INNER WEST

DEVELOPMENT ASSESSMENT REPORT

Application No.	DA/2020/0676
Address	4 King Lane BALMAIN NSW 2041
Proposal	Rear two storey addition and internal changes
Date of Lodgement	18 August 2020
Applicant	Oikos Architects
Owner	Ms Corinne G Patching
Number of Submissions	Initial: 1
Value of works	\$199,400.00
Reason for determination at Planning Panel	Clause 4.6 variation exceeds 10%
Main Issues	FSR variation, heritage
Recommendation	Approved with Conditions
Attachment A	Recommended conditions of consent
Attachment B	Plans of proposed development
Attachment C	Clause 4.6 Exception to Development Standards

PLAN - FIRST FLOOR
Scale 1:100

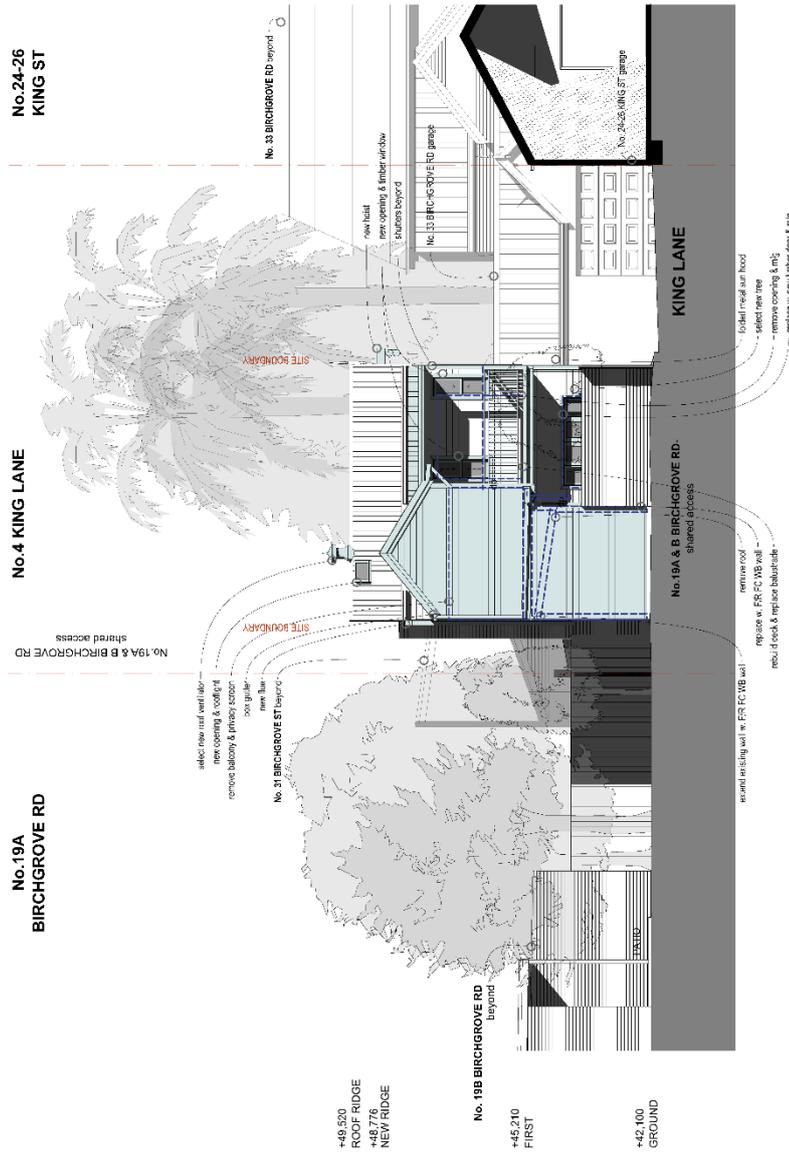
- *The cantilevered element of the first floor over the ground floor is not characteristic of development within the HCA and as such is not supported.*

Comment: It is noted that cantilevered elements are generally not typical within the HCA. Despite this, the existing first floor balcony is currently cantilevered 500mm over the ground floor. The proposal seeks to maintain the existing 500mm cantilevered design to ensure that dwelling will have improved internal amenity on the first floor without compromising the POS and proposed landscaping at the ground floor. Given that the King Lane streetscape is dominated by garages and outbuildings to dwellings that have a primary frontage to Birchgrove Road and King Street, the cantilevered design although visible from the southern end of King Lane will not visibly detract from the streetscape pattern. The design change recommended by Council's Heritage officer is therefore not included as part of the recommended conditions.

This drawing is protected by copyright law. Check all work on site and report any discrepancies to the architect.
Drawing Title: **ELEVATION- SOUTHEAST**
Scale: 1:100@A3; 1:50@A1
Date: 16/07/20
Drawing No: 20201172.3
Plotted: 16/07/20

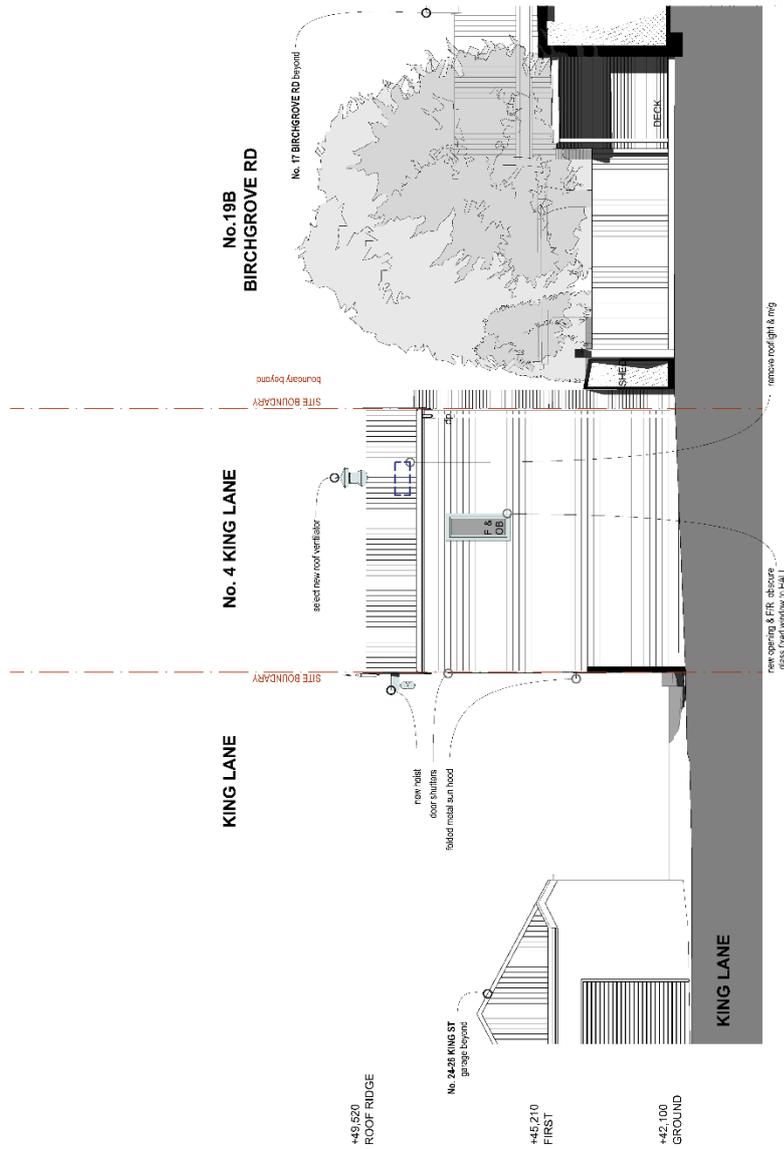
- The verandah roof over the first floor balcony is to be lowered so it sits below the existing eave and gutter of the roof plane on the south east elevation;*

Comment: The provisions under C3 b. and C6 of Part C1.4 of the LDCP 2013 require developments within HCAs to retain whole roof forms. It is recommended that the verandah roof over the first floor balcony is lowered so it sits below the existing eave and gutter of the roof plane.

- a. The first floor side addition is to be amended from a gable to a skillion roof form. The skillion roof form is to pitch from a 2.1m wall height above the FFL of the first floor at the rear (south west) elevation to a wall height no greater than 2.4m above the FFL of the first floor at the King lane (north east) elevation.
- b. The verandah roof over the first floor balcony is to be lowered so it sits below the existing eave and gutter of the roof plane.
- c. The front fence is amended to a timber paling fence with no gaps between palings with a maximum height of 1.8m above the NGL
